FRONT HOOD GRILLE

EXTERIOR/INTERIOR TRIM

2. Front Hood Grille

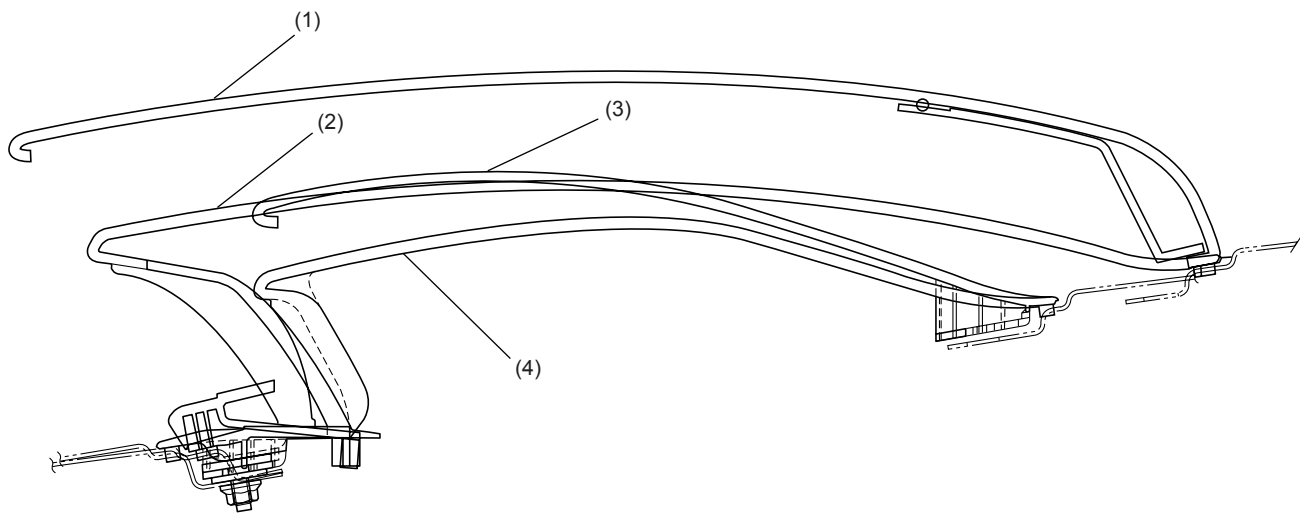
The opening is widened to enhance the cooling performance of the intercooler.
